Japan's Comment to TRANS/WP.29/GRSP/2005/3

Transmitted by the expert from Japan

Japan proposes to insert the following texts of the legform test method into Pedestrian Safety Global Technical Regulation Preamble.

Figure 8a: Certification test for the Flexible Legform Impactor

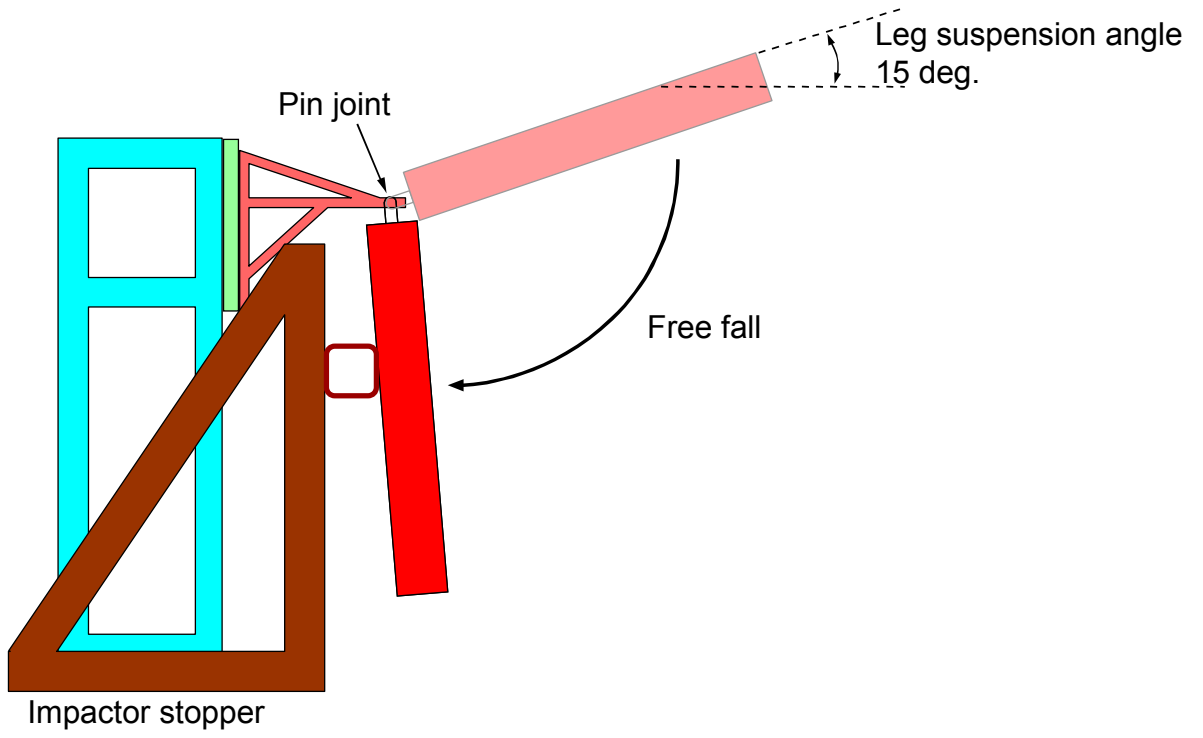
- 8.1.4.1. The impactor, including flesh, shall be suspended 15 degree above from horizontally, as shown in Figure 8a. It shall be suspended with its longitudinal axis vertical, with a tolerance of $\pm [2\text{ }^{\circ}]$. The impactor must meet the requirements of point 8.1.2.

Figure 8b: Impact location

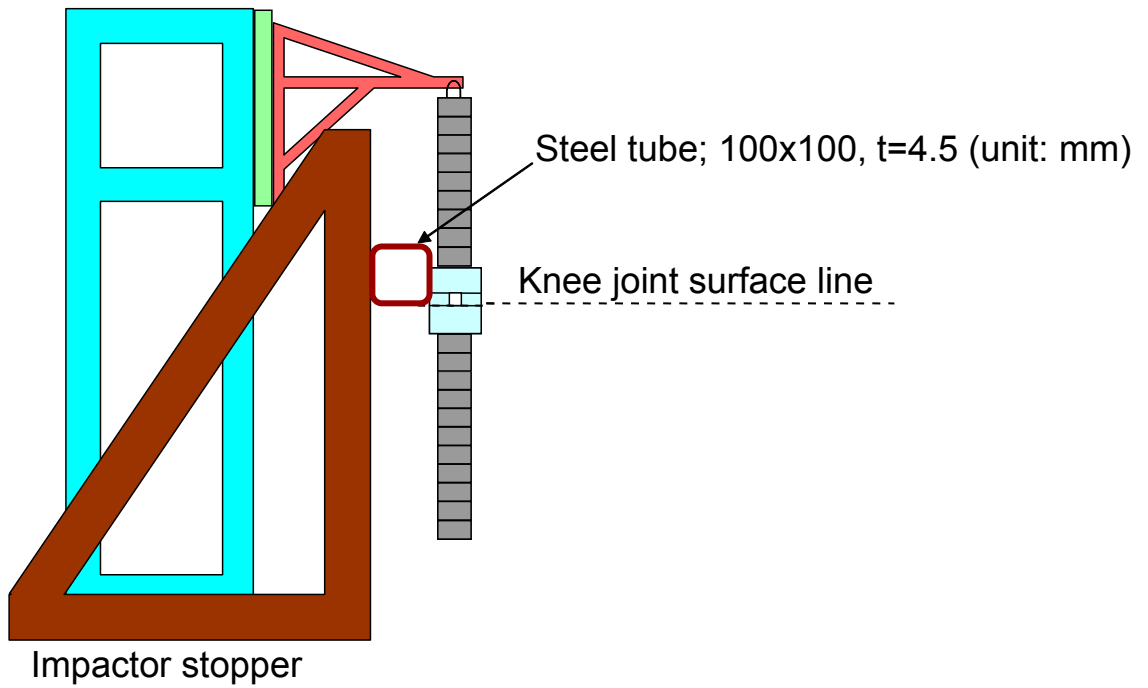
- 8.1.4.2. The impactor stopper shall have a rigid construction regarding the impact energy. The dimensions of the impacted face of the stopper and impact location shall be as specified in Figure 8b.
